Contract #: 04-0120F4Cty: SF/ALA Rte: 80 PM: 13.2/13.9File #: 69.25B**QUALITY ASSURANCE -- NON-CONFORMANCE REPORT****Location:** Changxing Island, Shanghai, P.R. China**Report No:** NCR-000290**Prime Contractor:** American Bridge/Fluor Enterprises, a JV**Date:** 30-May-2009**Submitting Contractor:** Zhenhua Port Machinery Company, Ltd (ZPMC), Changxing Island**NCR #:** ZPMC-0264**Type of problem:**

Bridge No: 34-0006**Component:** Splice Plate X202E, Crossbeam CB3/Segment 4BW**Reference Description:** Base Metal Damage During Tack Weld Removal, Crossbeam CB3/Segment 4BW**Description of Non-Conformance:**

Subject: NCR No. ZPMC-0264

Reference Description: Base Metal Damage During Tack Weld Removal, Crossbeam CB3/Segment 4BW

Draft of Welding Discontinuity:

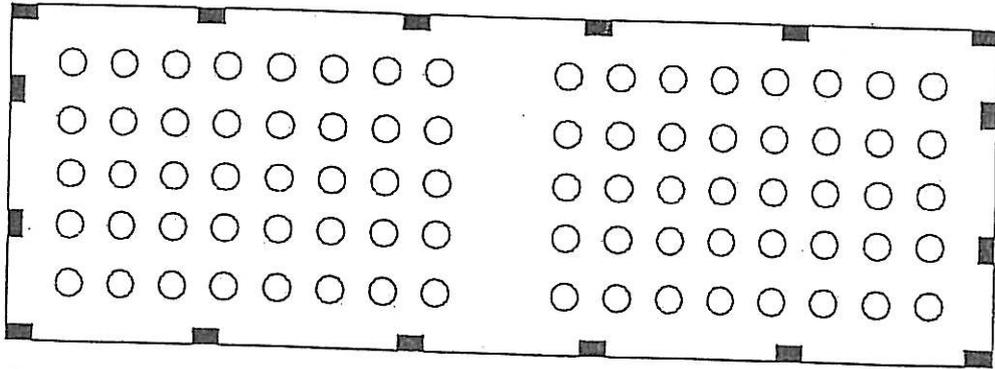
CB3连接板X202D,X202E在去除点焊时,有局部母材损伤,最大深度5MM. 见下图:
After inspection CB3 connect X202D and X202E, the base metal was gouged, maximum 5mm in depth, 500mm in length, total 4 parts, see the following draft.

1. QA CWI Presence.
2. Prepare excavation according to the approved repair WPS.
3. Grind the repair area to a smooth and shiny finish, with tapered ends, to ensure staggered starts and stops.
4. ~~VT and MT the repair area after grinding.~~
5. ~~Preheat and weld according to the relevant repair WPS for SPCM member.~~
6. Grind the repaired area flush with base metal or the adjacent weld.
7. Per AWS D1.5.3.2.2.3, welded repairs to the surfaces and edges of tension and reversal of stress Members shall be subject to ~~UT~~ and MT;
